# UNITED STATES PATENT AND TRADEMARK OFFICE

APPLICATION NO.	FILING DATE	FIRST NAMED INVENTOR	ATTORNEY DOCKET NO.	CONFIRMATION NO.
10/782,385	02/18/2004	Satoshi Mizutani	20050/0200895-US0	3573
7278	7590	11/29/2007		
DARBY & DARBY P.C. P.O. BOX 770 Church Street Station New York, NY 10008-0770			EXAMINER BOGART, MICHAEL G	
			ART UNIT 3761	PAPER NUMBER
			MAIL DATE 11/29/2007	DELIVERY MODE PAPER

# Office Action Summary

## **DETAILED ACTION**

**FIG. 18**

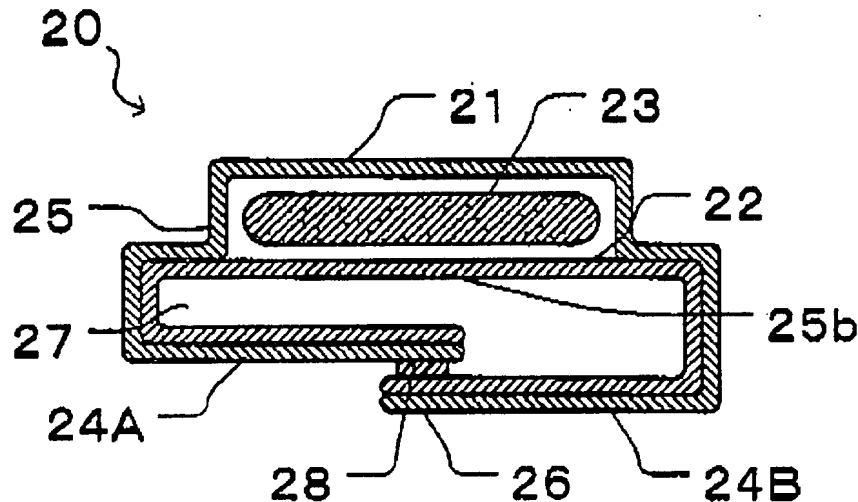
Regarding claim 1, Mizutani teaches an interlabial pad (20) comprising:

a first sheet (21) forming a surface side sheet configured contacting a body, the first sheet (21) having a permeable property for liquid;

a second sheet (22) independent from the first sheet (21) and forming a back face side sheet configured to be positioned away from the body, the second sheet (22) including a plurality of sheet pieces (24A, 24B), each partially overlapping another sheet piece;

an absorbent body (23) for absorbing liquid, the absorbent body (23) being disposed between the surface side sheet (21) and the back face side sheet (22);

a junction joining the surface side sheet (21) and the back face side sheet (22) at a peripheral edge of the absorbent body (23);

at least one seam part (26) of the second sheet (22) formed by overlapping the plurality of sheet pieces (24A, 24B) over one another, the seam part (26) including:

a longitudinal seam part (26) extending in a longitudinal direction of the interlabial pad (20), crossing over the second sheet (22) from an edge to another edge of the second sheet (22)

and an adhesive agent (28) applied between the sheet pieces (24A, 24B) at the longitudinal seam part (26) along a longitudinal central line along the longitudinal direction, wherein the sheet piece (24A), which overlaps the other sheet piece (24B) at the longitudinal seam part (26) and which covers a side closer to the longitudinal central line of the interlabial pad (20), is positioned at the absorbent body (23) side of the second sheet (22) and wherein the sheet pieces (24A, 24B) are each formed of either a water disintegrable material or a biodegradable material to enable separation of the second sheet into the sheet pieces (24A, 24B) when discarded by flushing (§ 0074).

Regarding claims 9 and 20, Mizutani teaches that the back face side sheet (22) is made uneven at least at the surface opposite the absorbent body (23) side (see fig. 18, *supra*).

**FIG. 30**

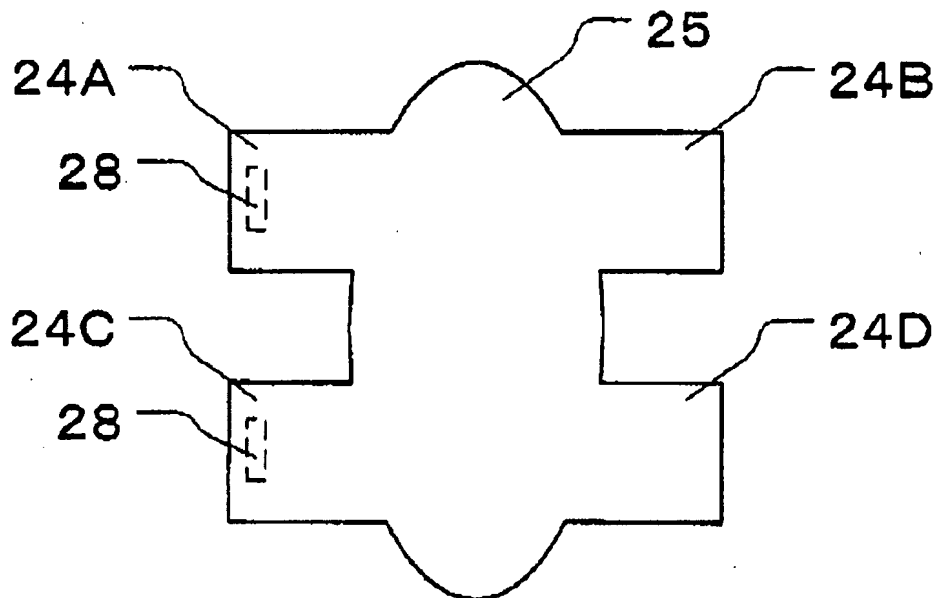
Regarding claims 6, 7 and 23, Mizutani teaches a lateral seam part (25) and a sheet piece (24A) overlapping a sheet piece (24B) at the seam part (see fig. 30, *infra*). Regarding the functional limitations of the claim, apparatus claims must be structurally distinguishable over the prior art. MPEP § 2114. The device of Mizutani can be folded in the claimed manner.

FIG. 1

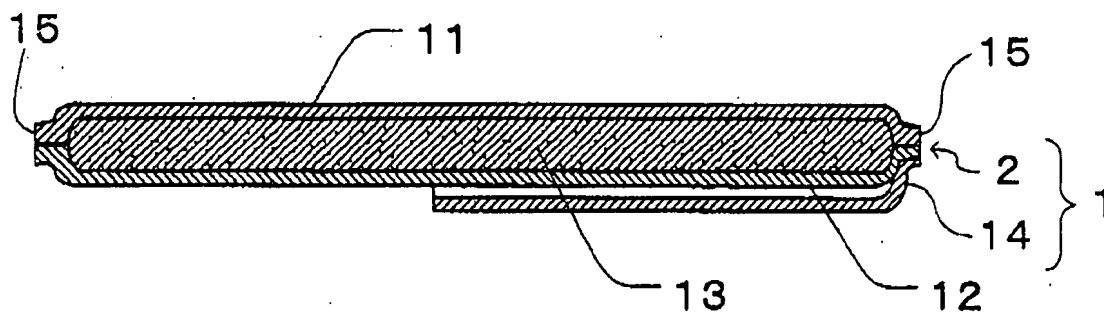
Regarding claim 27, Mizutani teaches a mini sheet piece (14) attached at the junction (2) of sheets (11) and (12)(see fig. 1, *infra*).
